# Access Compliance Report

## Public Rights-of-Way

Intersection ID: 11499	Main Street: TIMBERTOP_LN	Cross Street: VERONICA_DR	Location: SW
ADA ID: CDCD90C5792B	Ramp Type: PerpDiag	Initial Pass/Fail: Fail	Overall Compliance: No
		Severity Score: 10

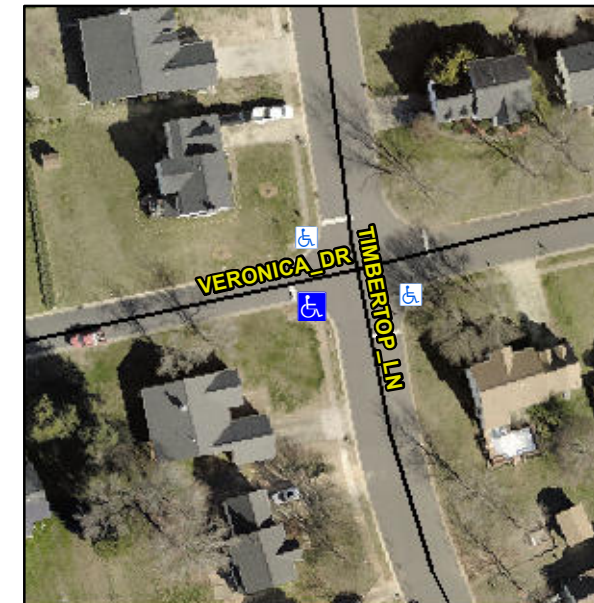
**Not Found, R304.5.1, R304.5.3**

Compliance	Description	Data	Compliance	Description	Data
N/A	Ramp Length (in)	94.5	Yes	Ramp Slope (%)	5.9
No	Ramp Width (in)	47.0	No	Ramp XSlope (%)	2.9
N/A	Flare Type LT	N/A	N/A	Flare Type RT	N/A
N/A	Flare Slope LT (%)	N/A	N/A	Flare Slope RT (%)	N/A
N/A	Flare Traversable LT?	N/A	N/A	Flare Traversable RT?	N/A
N/A	Landing Length (in)	N/A	N/A	DWS Provided?	N/A
N/A	Landing Width (in)	N/A	N/A	DWS Contrast?	N/A
N/A	Landing Slope (%)	N/A	N/A	DWS Length (in)	N/A
N/A	Landing X Slope (%)	N/A	N/A	DWS Full Width?	N/A
N/A	Landing Curb? (Y/N)	N/A	N/A	DWS Offset (in)	N/A
N/A	Shared Landing?	N/A			
N/A	Gutter Ponding?	N/A	N/A	Gutter Slope (%)	N/A
N/A	Gutter Lip Ht (in)	N/A	N/A	Gutter X Slope (%)	N/A
N/A	Painted X Walk1?	No	N/A	Painted X Walk2?	No
	X Walk 1 Direction	To E		X Walk 2 Direction	To N
N/A	X Walk 1 Width (in)	N/A	N/A	X Walk 2 Width (in)	N/A
	X Walk 1 Slope (%)	3.5		X Walk 2 Slope (%)	1.6
	X Walk 1 X Slope (%)	2.4		X Walk 2 X Slope (%)	3.0

**Remove & Replace Curb Ramp With Two New Directional Ramps or Equivalent.**
